**Flood Control Project Maintenance
Levee Inspections**

Fall 2019 Levee Maintenance Deficiency Summary Report

San Joaquin River Basin

Reclamation District No. 2075 McMullin

Photo 1 of 3 : SJR2019_RD2075U01RM64.34_1.jpg

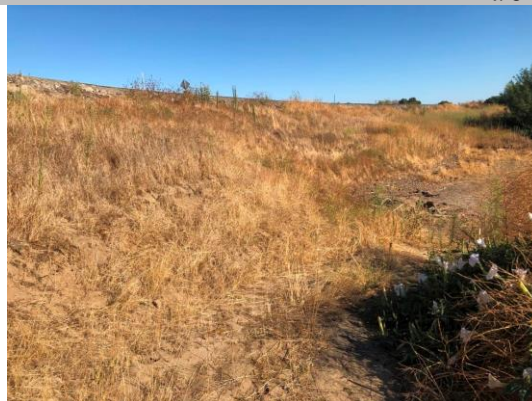
Comment Code						
Inspector Comment						
Site ID: RD2075U01RM64.34 09/17/2019: No significant change observed. 09/13/2017: No significant change observed. 07/12/2016: No significant change observed. 08/28/2015: No significant change observed. Loose material is visible at the upper levee slope. The loose soil may have been caused by runoff. 08/18/2014: No significant change observed. 09/10/2013: No significant change observed. 09/13/2012: No significant change observed. 08/18/2011: No significant change observed. Some new material added to the water side levee slope, but the added material is loose and seems not helping the levee protection. 10/05/2010: No significant change observed. Levee slope has minimal vegetation and lacks rip rap protection. Sandy material found on the lower and middle slope is an undesirable material to have on a levee. 08/05/2010: Recommended for annual assessment and monitoring during flood events, per CLRO. 08/20/2009: No major change since last visit; site is located in an oxbow; slope surface consists of very sandy material; there is a tree on site leaning and with exposed tree roots; site is recommended as a local maintenance issue, per CLRO CES Evaluation 2008 Report; Eddy Cordoza from the district is aware of the site and is looking for recommendation; site is previously rated "U". 08/17/2007: Site is close to an irrigation pump inlet.
